Subject: EES comments on Environmental Impact Statement for Light Horse Interchange Business Hub Eastern Creek – SSD 9667 – 165 Wallgrove Road and 475 Ferrers Road Eastern Creek

Subject: EES comments on Environmental Impact Statement - Light Horse Interchange Business Hub Eastern Creek – SSD 9667 – 165 Wallgrove Road and 475 Ferrers Road Eastern Creek

Precinct 6 and in the vicinity of the Western Sydney International Dragway (see Parklands precincts and Wallgrove Precinct 6 below from WSP PoM).

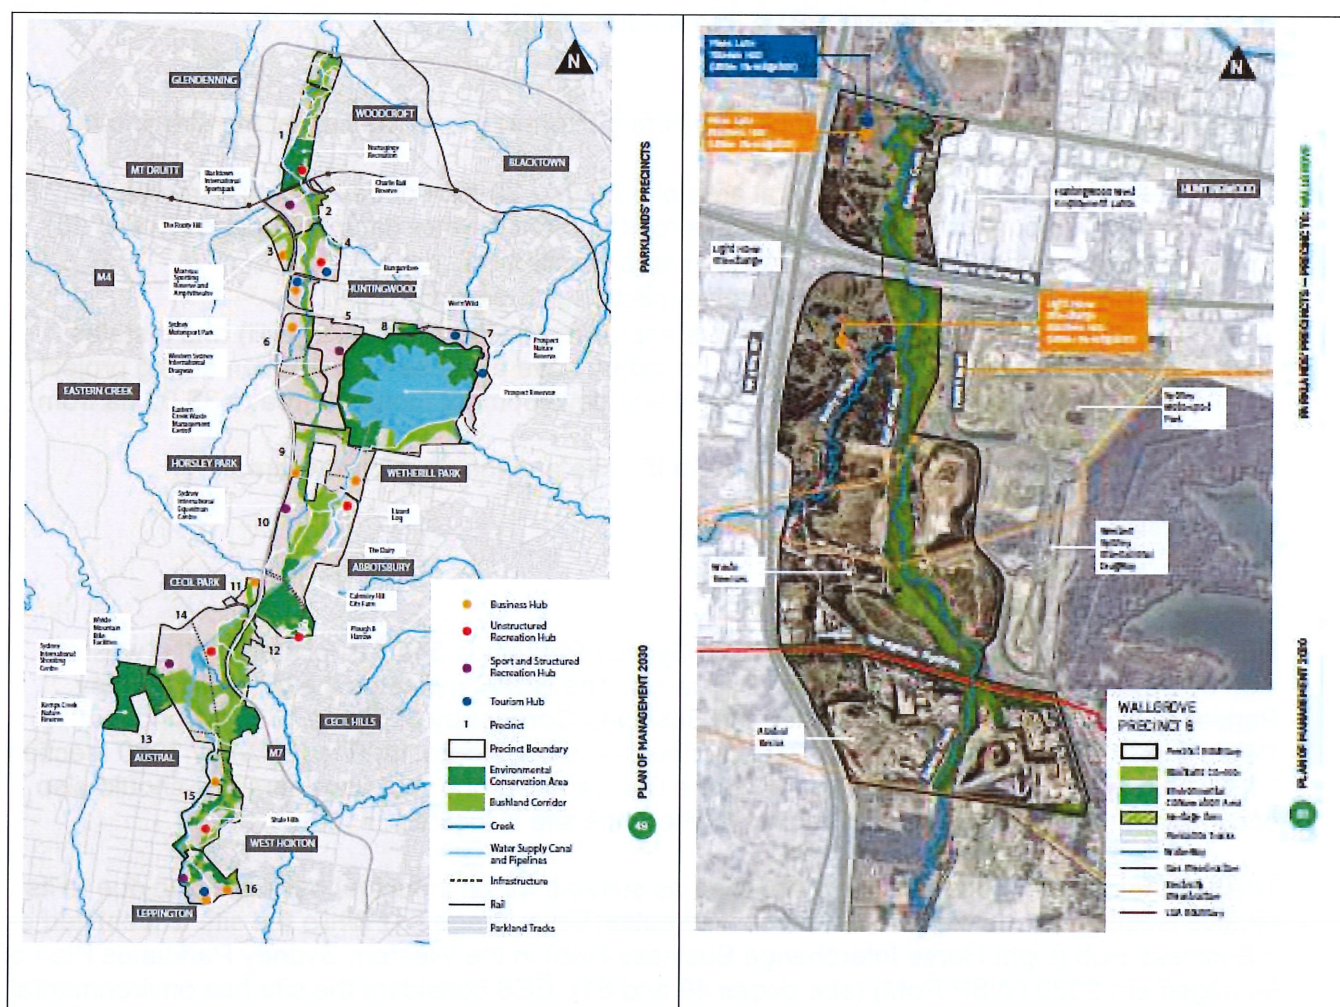
Compared to elsewhere in the WSP, the Bushland Corridor in Precinct 6 is constrained and is reduced in width by development, especially adjacent to Austral Bricks in the southern part of

The proposed development of the site will further remove the potential to widen and expand the Bushland Corridor along this section of Eastern Creek as it will remove and narrow the area that currently consists of open vacant grassland and native vegetation.

EES recommends the Bushland Corridor is widened in Precinct 6 to improve the robustness of the Western Parklands corridor, particularly as the WSP PoM indicates visitor numbers are increasing and there is now 150 000 walkers and cyclists using the Parklands tracks annually and there is 1.35 million visits per year to the Parklands picnic areas and playgrounds (page 18). The WSP PoM indicates that other landuse opportunities within Precinct 6 include walking and cycling tracks, unstructured recreation etc (page 60). Development along either side of the Bushland Corridor will act to constrict the increasing visitor / recreational use into the Bushland Corridor. EES is concerned that this will place pressure on the Bushland Corridor and impact and disturb the remnant native vegetation, the habitat it provides and the native fauna that use it.

EES recommends the Bushland Corridor is widened along the western side of the creek to include part of the site and that a buffer area is provided between the Light Horse Interchange Business Hub development and the Bushland Corridor to assist in protecting and enhancing the natural systems of the Western Parklands and achieving aim (d).

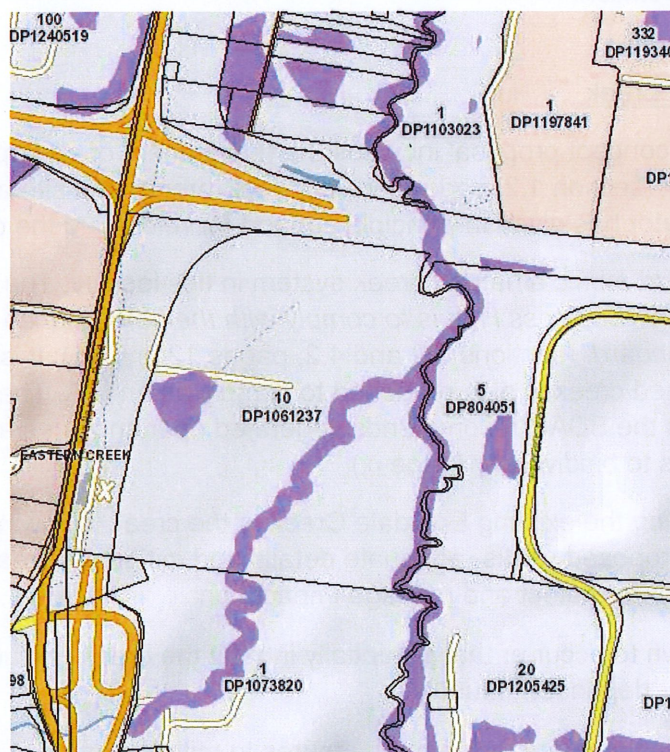
EES recommends all attempts are made to:

- reduce the footprint of the development on the site to avoid/minimise the clearing of native vegetation and widen the Bushland Corridor, and fully justify any unavoidable impacts
- remove horse and cattle agistment from the native vegetation that is to be retained as the BA states this is keeping the vegetation from regenerating outside of the riparian corridors (see section 1.2, page 3 of BA)
- retain isolated native paddock trees in the proposed subdivision and street layout.
